Access Compliance Report

Public Rights-of-Way

Intersection ID: 10021845	Main Street: BRIXHAM_HILL_AV	Cross Street: N/A	Location: NW
ADA ID: 6FAA81816F06	Ramp Type: Perp	Initial Pass/Fail: Fail	Overall Compliance: No
		Severity Score: 1.25

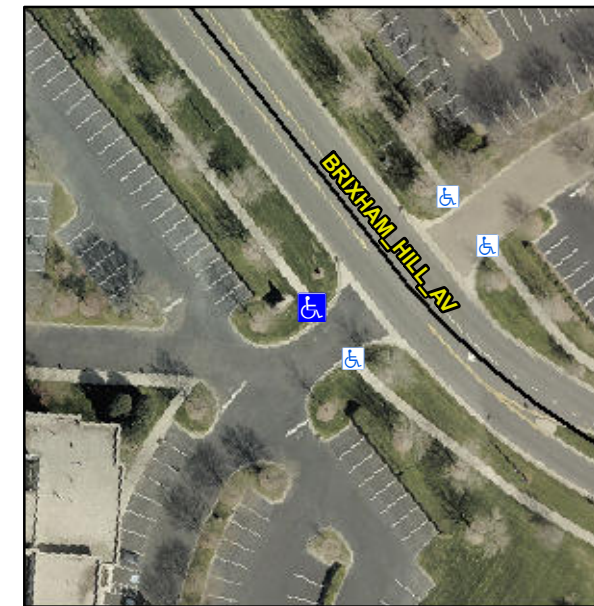
PROW/ADA:

Not Found, R304.5.3

Compliance	Description	Data	Compliance	Description	Data
N/A	Ramp Length (in)	71.0	Yes	Ramp Slope (%)	5.3
Yes	Ramp Width (in)	58.0	No	Ramp XSlope (%)	2.4
N/A	Flare Type LT	N/A	N/A	Flare Type RT	N/A
N/A	Flare Slope LT (%)	N/A	N/A	Flare Slope RT (%)	N/A
N/A	Flare Traversable LT?	N/A	N/A	Flare Traversable RT?	N/A
N/A	Landing Length (in)	N/A	N/A	DWS Provided?	N/A
N/A	Landing Width (in)	N/A	N/A	DWS Contrast?	N/A
N/A	Landing Slope (%)	N/A	N/A	DWS Length (in)	N/A
N/A	Landing X Slope (%)	N/A	N/A	DWS Full Width?	N/A
N/A	Landing Curb? (Y/N)	N/A	N/A	DWS Offset (in)	N/A
N/A	Shared Landing?	N/A			
N/A	Gutter Ponding?	N/A	N/A	Gutter Slope (%)	N/A
N/A	Gutter Lip Ht (in)	N/A	N/A	Gutter X Slope (%)	N/A
N/A	Painted X Walk1?	No	N/A	Painted X Walk2?	N/A
	X Walk 1 Direction	To SE		X Walk 2 Direction	N/A
N/A	X Walk 1 Width (in)	N/A	N/A	X Walk 2 Width (in)	N/A
	X Walk 1 Slope (%)	9.5		X Walk 2 Slope (%)	N/A
	X Walk 1 X Slope (%)	0.3		X Walk 2 X Slope (%)	N/A

Possible Solutions:

Remove & Replace Entire Ramp.
